Article written in support of membership upgrading .

# **Roads and Traffic Management in Sulaymany and its Suburban Areas**

**( A Critical review on Geometric Design of the Roads & their associated components including Visible Road Markings and Traffic Signs & Signals )**

Figure ( 1 )

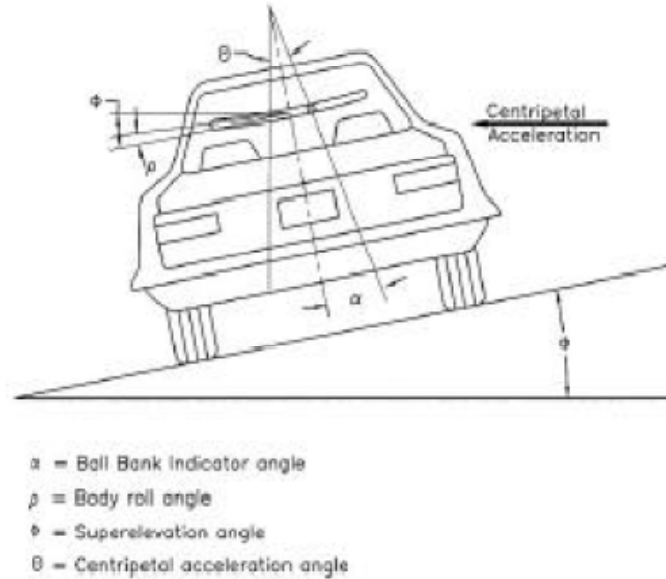
Roads leading through suburbs and to other towns which are mostly speedy roads in our mountainous region must comply with the Super Elevation requirements in their design on bends , which is worked out from a simple engineering procedure , See figure ( 1 ) , for this purpose , Road Designers can follow AASHTO Standard Code , but in fact they seem they did not, or otherwise , the implementing team failed to comply with . As examples ; the roads leading to Dokan , Koya , and to Hiran and Shaqlawa . ( More details can be obtained on request from my e-mail address given at the end of this article ) .

Figure ( 4 )

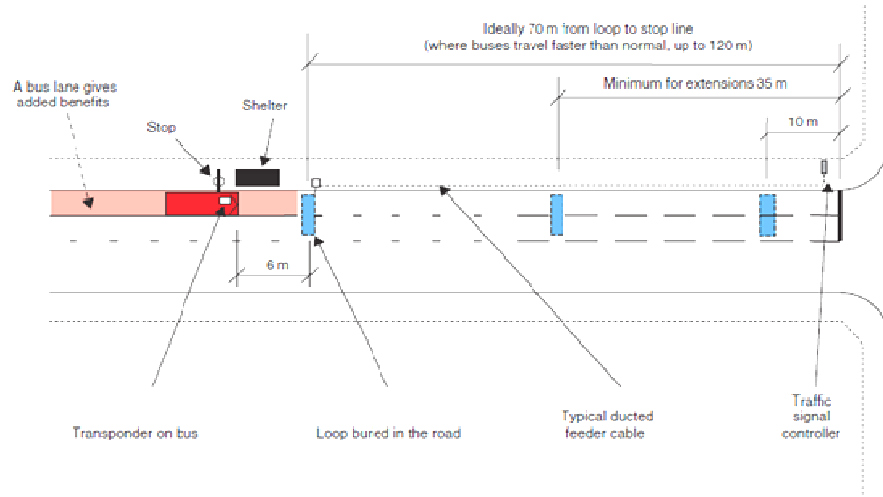
Divide up roads in to two lanes , 1<sup>st</sup> of which to be marked for Emergency Vehicles and Public Bus lane which in turn may be sub-divided into narrower Green colored lane for use by Cyclists & Motor Bike riders , and the 2<sup>nd</sup> for general use by vehicles in general . See figure ( 2, 3 & 4 ) . These types of marking have not been seen so far in our region and to set an example , The Emergency Hospital is situated within a set of very narrow roads all around in a crowded market area behind the Civil Court Building , Emergency Vehicles getting in and out of the place, should get through slow traffic of inappropriate roads having no design considerations for such cases .

Having the main roads divided up into two lanes , marked accordingly to distinguish between the Emergency Lane and the other, will help easing up on such cases as for the Hospital / or other E. Vehicles of say Police or Fire Extinguishing Brigades , equally, Cyclists and Bike riders can safely use it all the time .
